Modification Notes

nhess-2023-136

Title: Optimization strategy for flexible barrier structures: Investigation and back analysis of a rockfall disaster case in southwestern China

Figure 1: Structure representation of the actual model (Act_) and the comparative analysis model (Comp_). (a) Act_SEL and Act_MEL. (b) Act_Sts and Comp_Sts.

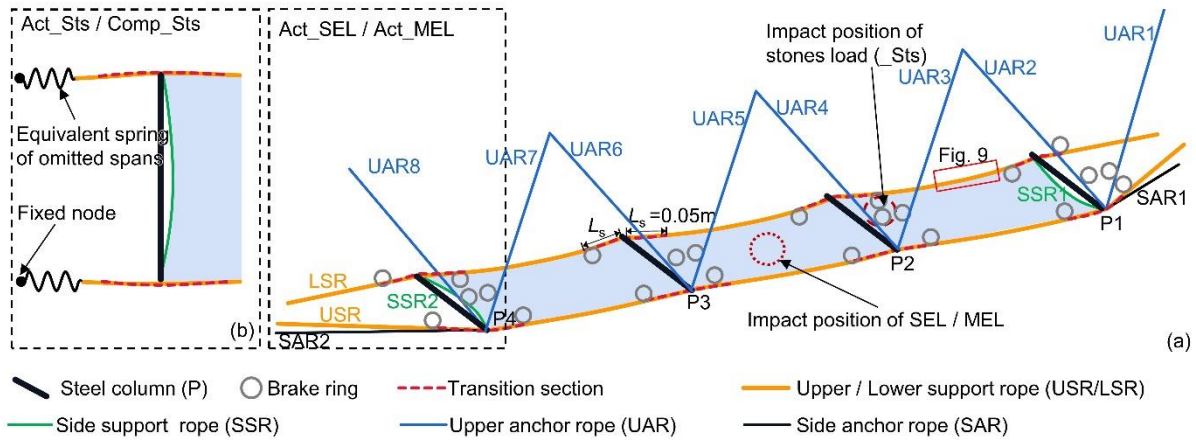
8. In general in the text the acronyms are note specified please add a figure or a table specifying the meaning of them, otherwise some figures and some text portion are not understandable. Furthermore, it is need a table to specify the model parameter values used in the numerical simulations.

Response : Tow figures and an appendix of abbreviations have been added in order to enhance the understandable of the acronyms and symbols. Furthermore, Table 3 has been updated to show the parameter values used in the numerical simulations.
